8A Miscellaneous Electrical Systems

The information in this appendix of the reference ABWR DCD, including all Subsections and figures, is incorporated by reference with the following departures and supplements.

Figure 8A-1 Site Plan (Grounding)

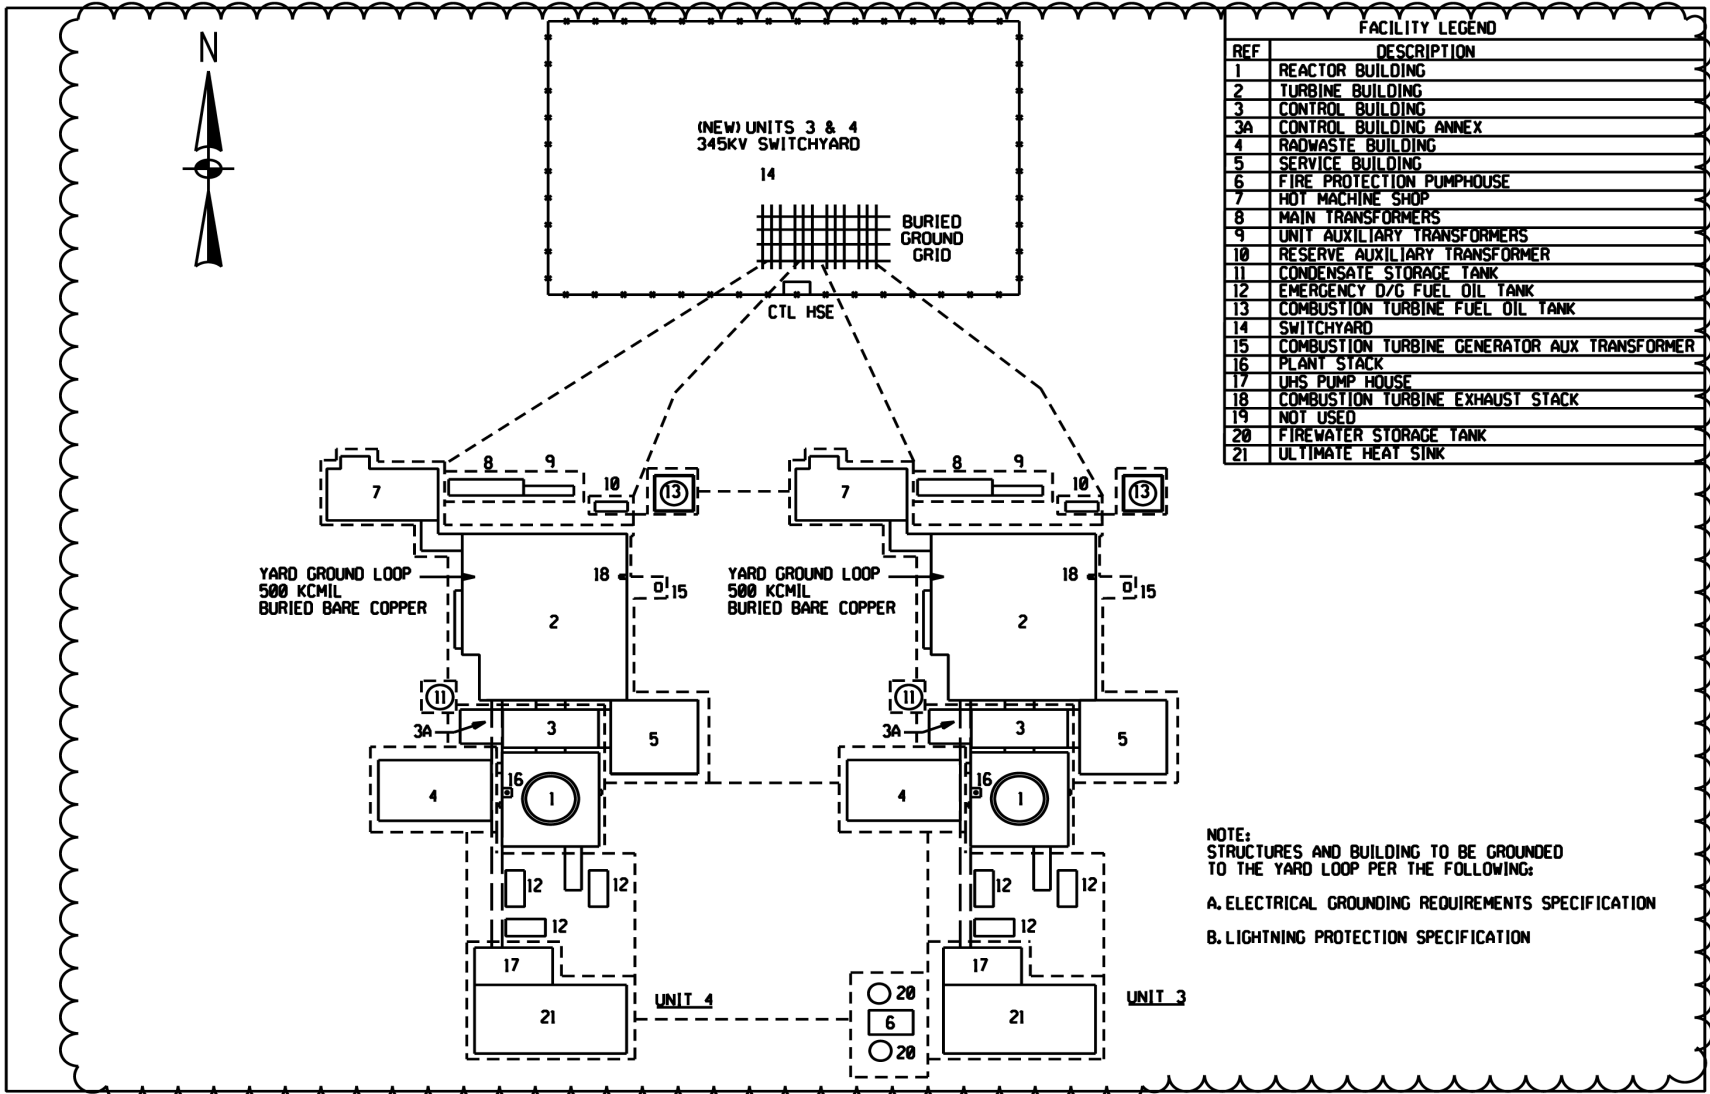
STP DEP 1.1-2 (Figure 8A-1)

- (3) A plant grounding grid shared between STP Units 3 & 4
